Section 42A Report

Report on Private Plan Change 61

R&C Wright request to rezone Rural Outer Plains to Business 2 & Living 1 Zones, east of Darfield

23 March 2021

Figure 6 – PC61 ODP overlayed with 300m intensive farming buffer

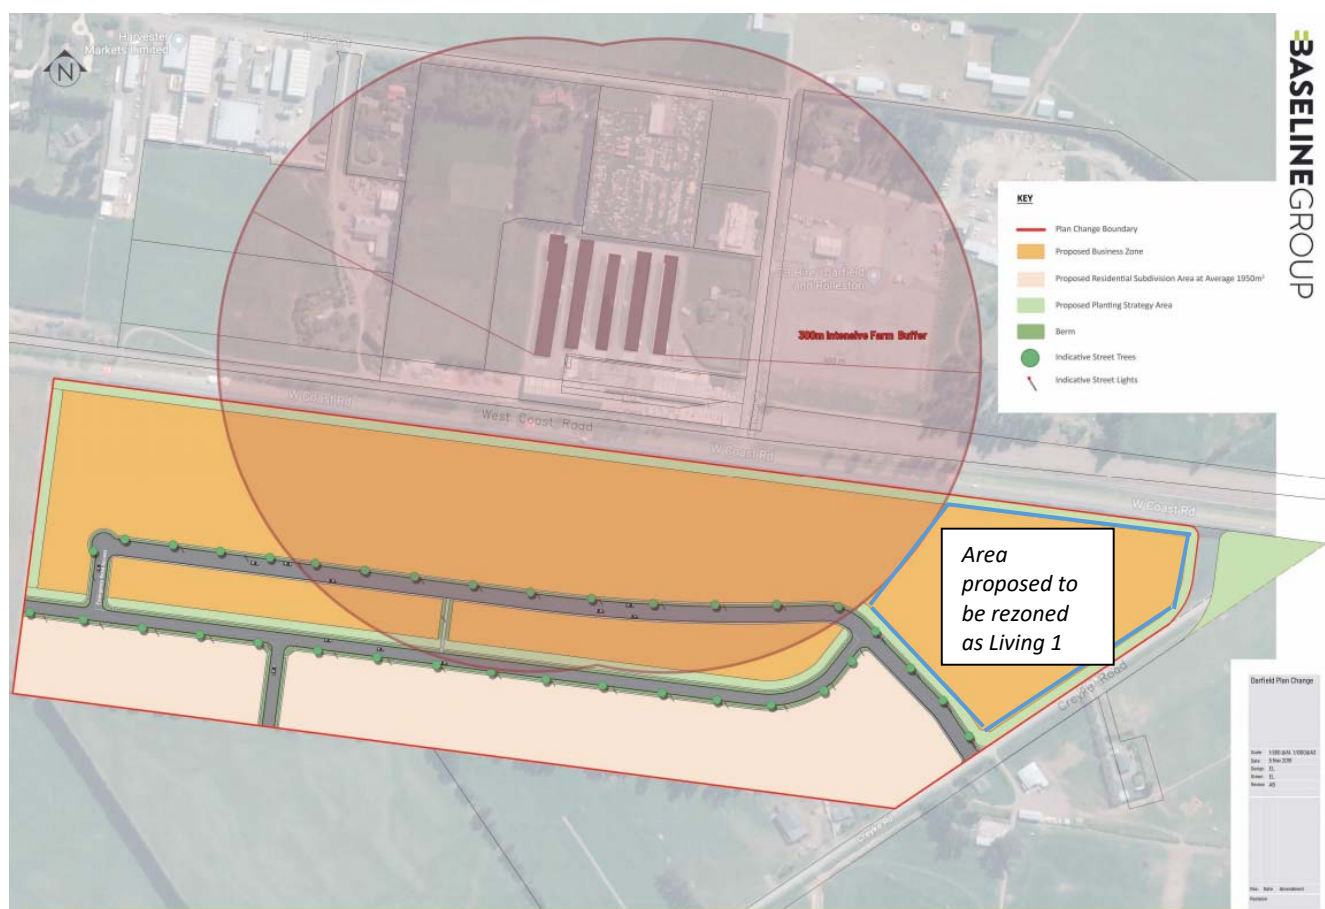
- 62) The ODP provided in the application shows that residential development will be located in the southern and eastern part of the site, away from the poultry farm. Under Rule 3.13.1.5 in the Rural Volume of the Selwyn Operative District Plan, sensitive activities in the rural zone, such as residential activities, are required to be setback 300m from intensive farming activities. Applying this approach to the residential development proposed in the plan change as a rough proxy for exposure to adverse effects, it is apparent that the proposed Living 1 zone in the development under the revised ODP is outside of the 300m buffer.

- 63) I therefore agree with the applicant that a sufficient buffer is capable of being put in place between the poultry farm and the proposed residential development. As noted earlier, the Business 2 zoning enables a wide range of activities, which could include potentially include sensitive activities under limited circumstances (for example residential units for security or custodial purposes as a controlled activity). However, given the permitted baseline and tolerance of effects in the Business 2 zone, I do not consider that the existing poultry farm will have a significant adverse effect on this proposed zone.

- 68) Taking this into account, I consider that the 10m proposed internal setback as it would apply to the revised ODP in the north east of the site is insufficient and that the applicant needs to demonstrate a more suitable buffer is in place between the immediately adjacent business and residential zones, to ensure there is a consistent approach.

Figure 8 – Ascot Park Subdivision – Approved Staging Plan (Potential Connection to PC61 Added)

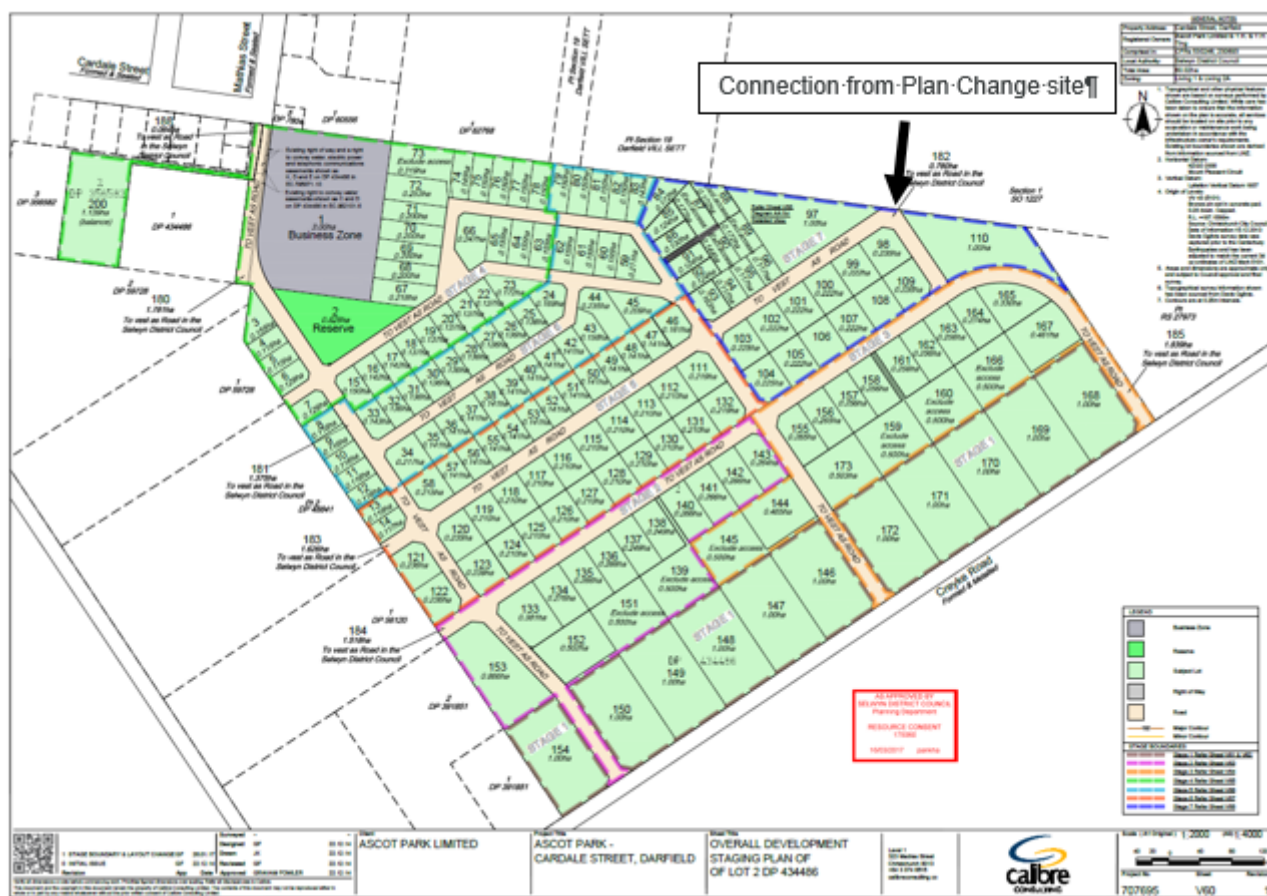
- 87) In terms of considering alternatives, Mr Smith considers that the approved subdivision plan for Ascot Park does not explicitly account for a connection from the PC61 ODP area and any connection for traffic through the Ascot Park subdivision is likely to be somewhat circuitous, and is unlikely to be substantial in terms of improved vehicular connectivity to the wider network. However he does support a walking and cycling link in this vicinity to encourage uptake of these modes and provide a safer, lower speed alternative to walking and cycling along SH73.

Figure 9 – Darfield 5 Developed Area – Proposed Selwyn District Plan (Potential Connection to PC61 Added)

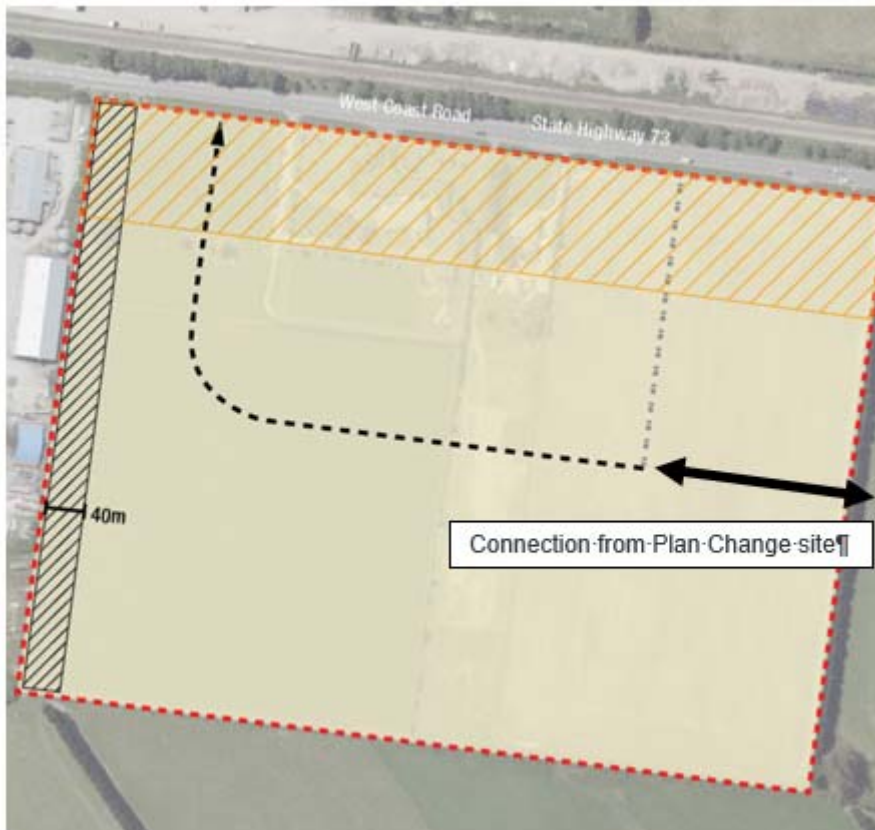
- 88) He also considers the opportunity to utilise the site to the west, included in the Proposed Selwyn District Plan as Darfield Development Area 5 (DEV-DA5). The PC61 ODP has proposed a connection into this Development Area which Mr Smith supports and considers this connection is needed to provide safe and direct walking and cycling connectivity to Darfield Township from the application site and notes this would be a more direct connection from the Plan Change site to Darfield than the proposed connection through Ascot Park. Whilst this could include private vehicle use, traffic associated with the industrial component of PC61 should be discouraged as it will pass through a residential area.

- 90) Mr Smith considers that the connection between the cul-de-sac and residential ODP link can be designed and/or restricted to ensure heavy vehicles associated with the business zone are not travelling through the residential streets. However, there will be no way of preventing smaller commercial vehicles from using it as a standard site access. As it is plausible that a connection between the ODP and the township is achieved through Development Area 5, the location of the proposed B2 zone emergency access could encourage commercial traffic to travel westwards to access the state highway network, thus routing this traffic through residentially zoned areas both within this ODP and Development Area 5.

- 91) Based on likely traffic volumes however, he considers it is well within the capacity of a residential local road and, subject to suitable design features restricting heavy vehicles associated with the business activity from accessing the residential streets at the western end of the Plan Change site.

Figure 10 – Proposed Groundwater Protection Zone

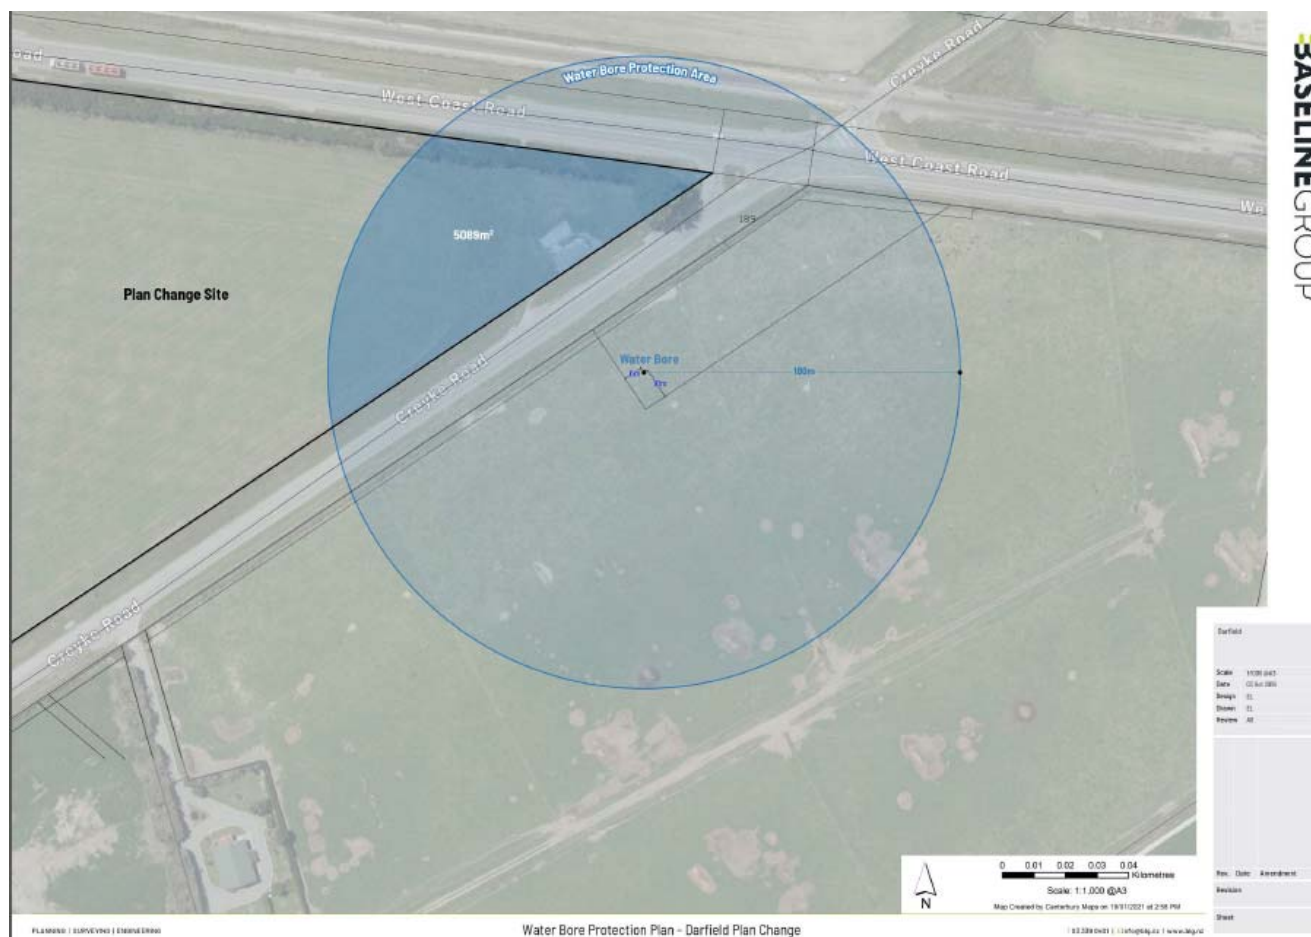
- 120) As detailed in the letter to Council dated 22 January 2021, the applicant acknowledges that a Ground Water Protection zone is required over a small portion of the plan change area to protect a new community water supply bore currently being drilled. No discharge of wastewater should occur in this area. The letter concludes that *'it is likely that coordination with Council's reticulated system is feasible at the time of design and construction'*.

- 125) I consider that there are no water based infrastructure network reasons why the plan change should not be granted. Whilst I acknowledge ECAN and the District Health Board's concerns around wastewater disposal to land and consultation on the possibility of future reticulation, at this time I consider that wastewater can be disposed of to land and dealt with by way of a resource consent under the Regional Land and Water Plan, which has been the case for other development on allotments smaller than that proposed by this Plan Change in Darfield. The consent process will also ensure that the discharge of stormwater or wastewater within the Groundwater Protection Zone is avoided.

Figure 1 Approved Plan for Ascot Park subdivision

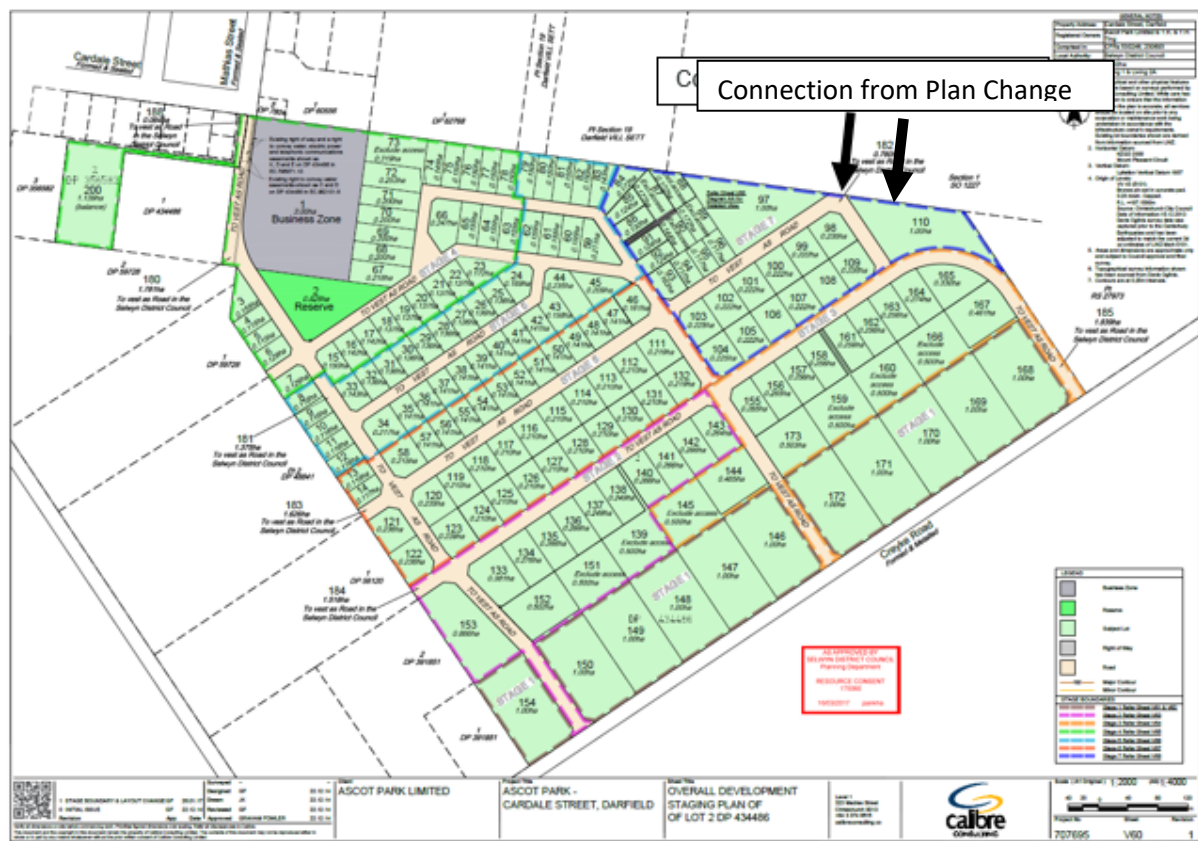
30. The approved subdivision plan for Ascot Park does not explicitly account for a connection from the ODP area. The connection would be to a local road that is primarily intended for property access and not through traffic. The routing through Ascot Park for ODP traffic to reach Darfield town centre is somewhat circuitous, and is unlikely to be substantial in terms of improved vehicular connectivity to the wider network. However I support a walking and cycling link in this vicinity to encourage uptake of these modes and provide a safer, lower speed alternative to walking and cycling along SH73.

Figure 2 ODP for Darfield Development Area 5

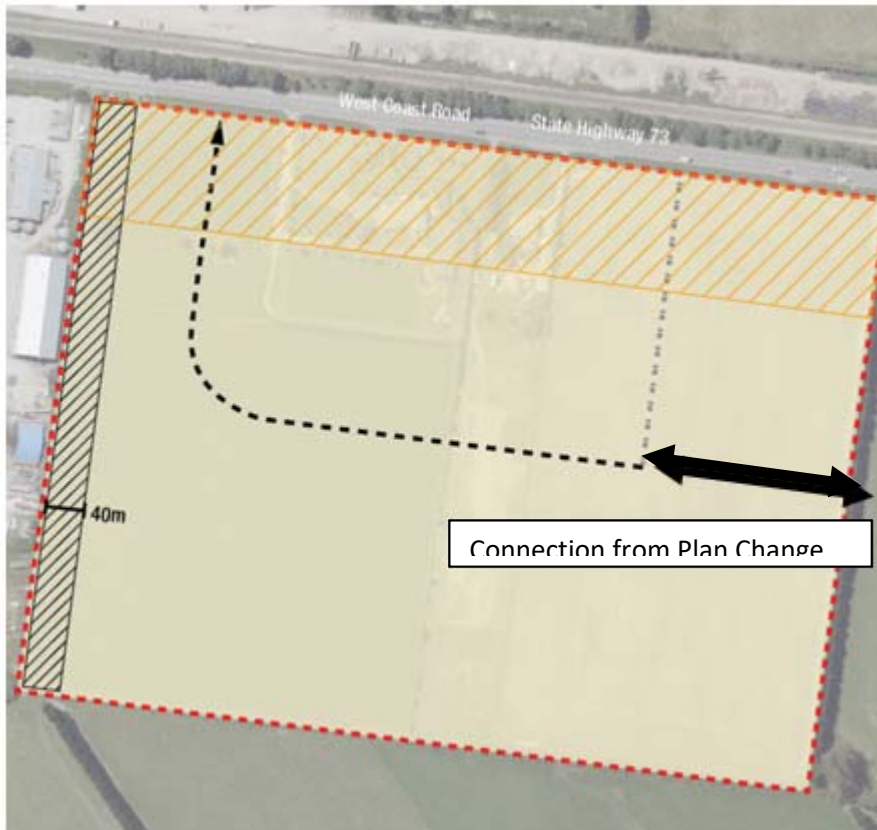
31. The site to the west is zoned as L2A (Deferred) and does not have subdivision consent. This site is included in the Proposed Selwyn District Plan (refer to <https://eplan.selwyn.govt.nz/review/#Rules/0/474/1/0/0>) as Darfield Development Area 5 (DEV-DA5) shown in Figure 2. The ODP has proposed a connection into this Development Area. I understand the potential for a through road to be formed to Mathias Street has been previously investigated by SDC, but that this would require going through existing developed business and or residential properties. I support including this connection to provide safe and direct walking and cycling connectivity to Darfield township from the application site. I note that this would be a more direct connection from the Plan Change site to Darfield than the proposed connection through Ascot Park.

Figure 3 Safe and Appropriate Speed from MegaMaps

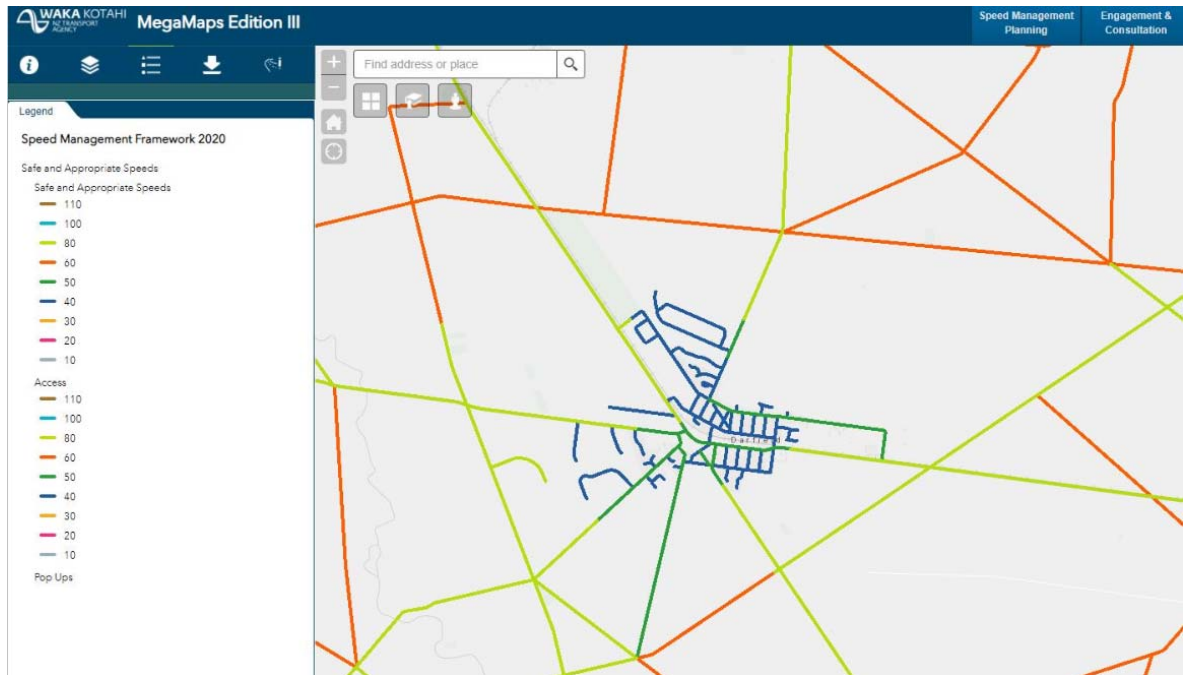
43. I have referenced Waka Kotahi's Speed Management Framework and MegaMaps tool to understand the appropriateness of reducing the speed along SH73. The MegaMaps tool is used by Waka Kotahi and other Road Controlling Authorities to provide an assessment of the Safe and Appropriate Speed (SaAS) of each road link on New Zealand's road network based on road safety risk in alignment with the Speed Management Framework. The SaAS is based on establishing the speed which is appropriate for each corridor based on the road function, design, safety and use of the corridor. Figure 3 shows that the SaAS along SH73 either side of Creyke Road through to the urban boundary and along Creyke Road is 80 kph, which is lower than the current 100 kph posted speed.

Figure 4 Top 10% DSI Saving Network Sections

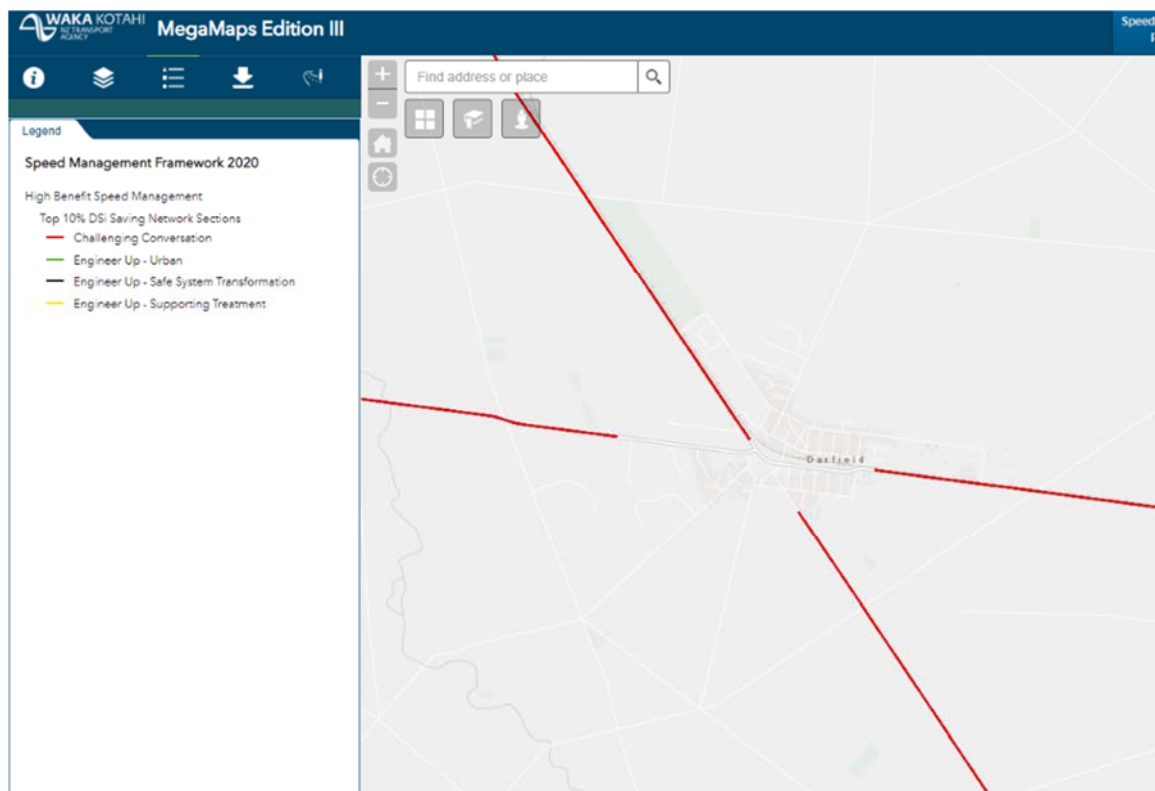
44. I have also identified from the MegaMaps tool that the SH73 corridor is classified as being in the top 10% of Death and Serious Injury (DSi) saving network sections as shown in Figure 4. This means that there are high safety-related benefits anticipated to be achievable through reducing the speed limit to align with the SaAS or from engineering up the corridor through safety improvements. In terms of process, I understand that further investigation would be required to confirm the SaAS is correct and this would be undertaken as part of a technical assessment known as a speed limit review. The Government Policy Statement 2018/19 – 2027/28 includes a target to address the top 10% DSi network sections, which indicates central government intent that a speed management review of this corridor may be planned or may be imminent.

45. I agree with the applicant that the setting of speed limits is not an RMA matter, however as the area becomes increasingly urbanised this issue becomes more pertinent. I encourage the relevant road controlling authorities to undertake speed limit reviews of SH73 and Creyke Road, and encourage discussions between the Applicant and road controlling authorities in this regard. I further note that residential development is already occurring fronting onto Creyke Road so in my view this would be an opportune time to review the appropriateness of the current speed limit.
